**PUBLIC HEARING MEMORANDUM**

SUBJECT: **Petition #216-21**, petition for SPECIAL PERMIT/SITE PLAN APPROVAL to allow a three story, 12-unit multi-family dwelling with an FAR of 1.5, to allow a ground floor residential use, to allow a building with more than 20,000 sq. ft., to allow a three-story structure with 36' in height, to alter and extend a nonconforming side setback, to waive two parking stalls, to reduce the width of parking stalls, ~~to allow a driveway width exceeding 25 feet~~ and to allow a retaining wall greater than four feet in height within the setback at 50 Jackson Street/383-387 Boylston Street, Ward 6, Newton Centre, on land known as Section 65 Block 11 Lot 4, containing approximately 14,866 sq. ft. of land in a district zoned BUSINESS USE 1. Ref: Sec. 7.3.3, 7.4, 4.4.1, 4.1.2.B.1, 4.1.2.B.3, 4.1.3, 7.8.2.C.2, 5.1.4, 5.1.13, 5.1.8.B.1, 5.1.8.D.2, 5.4.2 of the City of Newton Rev Zoning Ord, 2017.

**383-387 Boylston Street**

## ZONING REVIEW MEMORANDUM

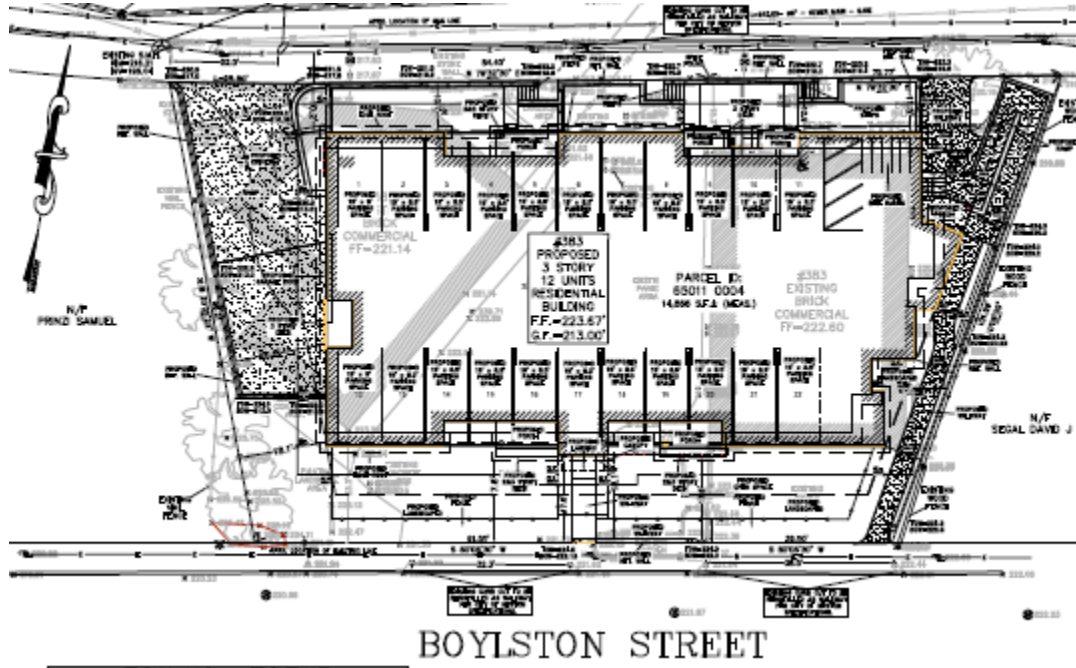
The front setbacks as proposed are 14.9 feet from Boylston Street and 10.1 feet from Jackson Street, where 10 feet is required.

The site would be accessed by one 22-foot-wide curb cut from Jackson Street. The entrance to the underground garage is accessed via the drive aisle along the western property line from Jackson Street. The petitioner proposes to construct a retaining wall along the western property line that starts at a height of three feet and reaches a height of ten feet, and then a maximum height of 12 feet where the entrance to the garage is located. The proposed retaining wall along the western property line to accommodate the grade change to the garage requires a special permit for its location within the side setback. Another retaining wall is proposed along the eastern property line that reaches a maximum height of 3.8 feet. The Planning Department understands the necessity of the retaining wall to accommodate the driveway and garage entrance, however staff suggests the petitioner consider measures that may reduce the height of the 10–12-foot wall. Plans show dumpsters at the end of the driveway that extends beyond the garage entrance. Planning questions whether trash pickup could be accommodated internally via a trash room which may result in a shorter driveway and a shorter retaining wall.

The petitioner submitted a landscaping plan showing landscaping throughout the site and along the Boylston Street and Jackson Street frontages. Planning Staff notes there is no proposed landscaping to screen the driveway and retaining wall from the residential abutter to the west at 62 Jackson Road. The petitioner should explore measures that would allow for increased buffering and/or distance of the driveway from the abutting property, especially considering the proposed height of the retaining wall within the setback.
